**FINAL EIR**

**COUNTY OF CONTRA COSTA  
COMMUNITY DEVELOPMENT DEPARTMENT**

**BUENA VISTA  
WIND ENERGY PROJECT  
LP# 022005**

April 2005

Source: Nov. 2004 DEIR  
Exhibit B

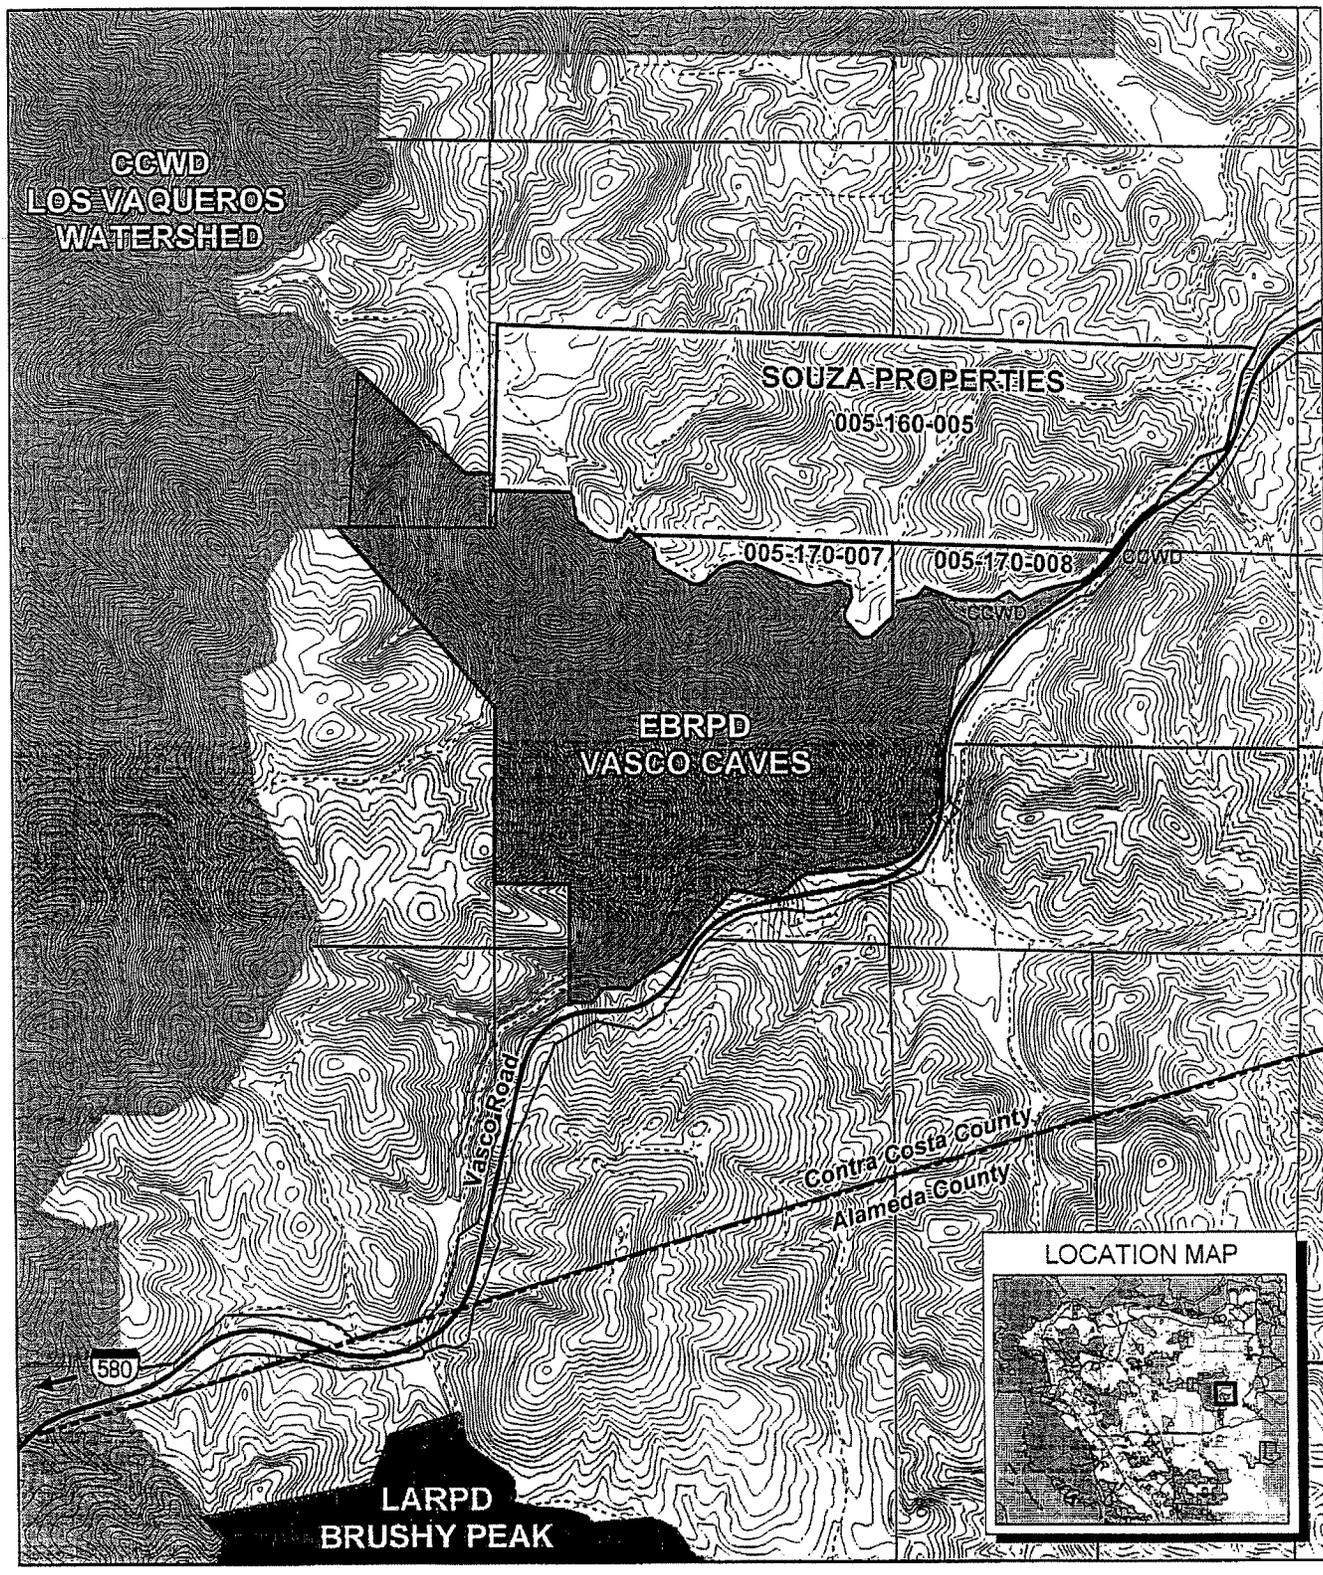
The former Souza property has three wind turbine leases, including a lease to Buena Vista who currently owns four inoperative turbines at the eastern end of the property. *See attached Exhibit B.* We previously requested that these four turbines be removed as visual impact mitigation for the earlier project. Since we have now acquired this property, we have already requested Buena Vista to remove these four turbines. Removal should include the turbines, transmission facilities and access road(s) to this location. The discussion on page 7-15 of the DEIR should make it clear that removing these four turbines does not mitigate the visual impact of the proposed repowering project; they help to reduce the existing visual impacts of the current wind turbine facilities to Vasco Caves.

- 8-1 As part of the Buena Vista Project described in the Draft EIR, the applicant does propose to remove the four existing wind turbines from the eastern end of the former Souza property, north of Vasco Road. As noted on page 3-41 of the DEIR, demolition and reclamation efforts include removing existing turbines, covering any remaining foundations with soil, removing existing electrical collection lines and reclaiming existing access roads. These efforts are part of the proposed Project, and are not recommended as additional mitigation measures. Their removal is part of the overall change in the visual character of the area that would occur under the proposed repowering project. The statements on page 7-15 of the DEIR regarding these turbines remain accurate.

Figure 7-1  
Simulation Viewpoint Map

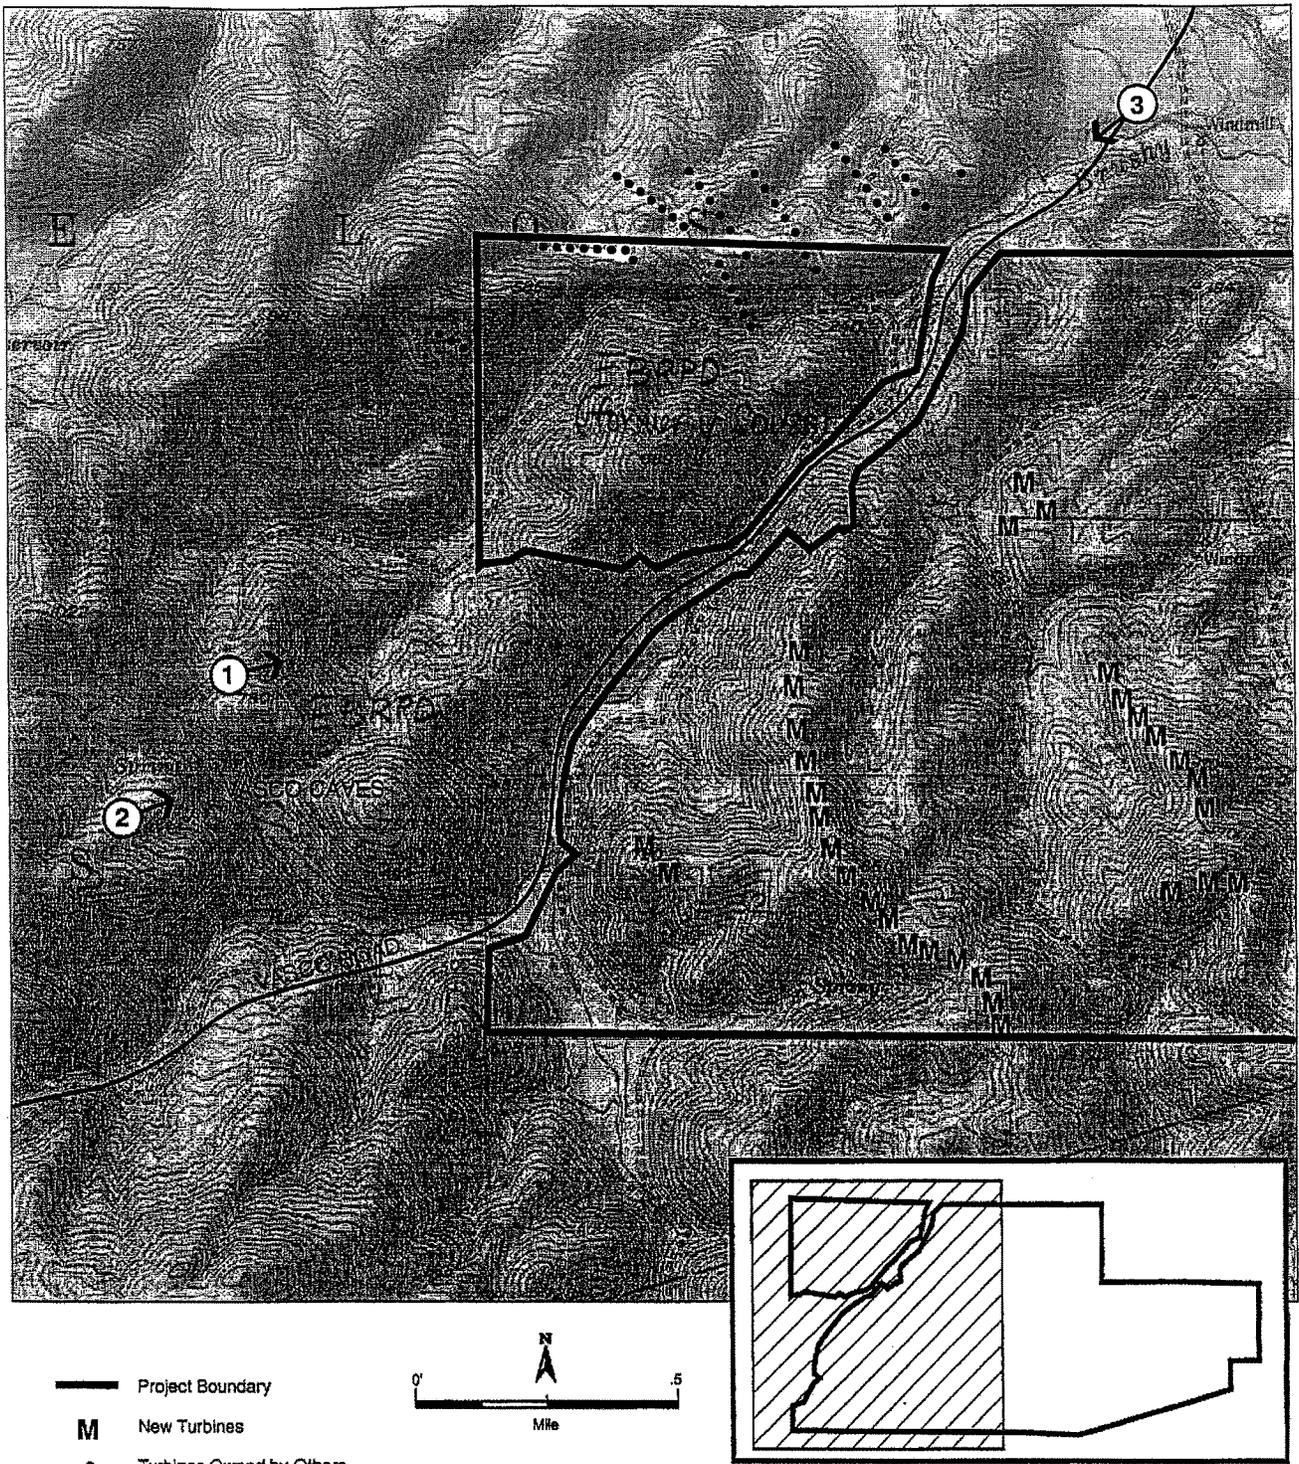
It appears that because Buena Vista can no longer place new wind turbines on the former Souza property that Buena Vista has instead proposed to construct five additional new turbines on private property, just east of Vasco Road and the eastern boundary of Vasco Caves Regional Preserve. This includes two new turbines designated as "String V". See attached Figure 2-3 of the DEIR, labeled as Exhibit C. These new turbines will result in new significant visual impacts to Vasco Caves that are not addressed or mitigated in the subject DEIR or in the earlier April 2005 DEIR. The two Visual simulations of views looking northeast from Vasco Caves were prepared for the earlier April 2004 DEIR and do not include the proposed String V turbines just east of Vasco Caves. See Figure 7-1 of the subject DEIR.

The proposed String V turbines would likely not be visible in the two visual simulation points shown of Figure 7-1 of the subject DEIR; however, they would be quite prominent from the lower rock outcrop area of the "Stone House Trail" and from the high point on the "Eagle Roost Loop Trail" at Vasco Caves. See attached Exhibit D. We request that the County or the applicant prepare a visual impact simulation of the proposed String V turbines in order to demonstrate the relative significance of the visual impact to Vasco Caves. Absent such information, the DEIR can draw no conclusion about the relative significance of this new visual impact or the effectiveness of measures proposed to mitigate this visual impact. We prepared a visual simulation of the two new proposed turbines based upon the assumption that they would measure approximately 240 feet tall to the tip of the blade. See attached Exhibit E. As you can see from the simulation, the two proposed String V turbines would be visually disruptive to Vasco Caves at potentially several locations.

- 8-3 The comment is correct that the two proposed String V turbines would not be visible in the specific views as simulated in Figures 7-2 and 7-3 of the DEIR. Nor would they be visible from numerous other vantage points within the Vasco Caves Regional Preserve where they would be obstructed by intervening topography. However, these proposed new turbines would be quite prominent from the vantage point shown in EBRPD’s Exhibit E (which appears to be a viewpoint high above the Stone Horse Trail at the top of the ridge at elevation of approximately 1,022 feet), from Vasco Road and from many other locations. New, large wind turbines located along any ridgeline in the western portion of the Buena Vista Project site (including those proposed on String V) would likely be visible from many portions of the Stone House Trail and/or the Eagle Roost Loop Trail. However, the DEIR did not find this visual prominence to be a significant environmental effect for the following reasons, as also described in the Draft EIR.
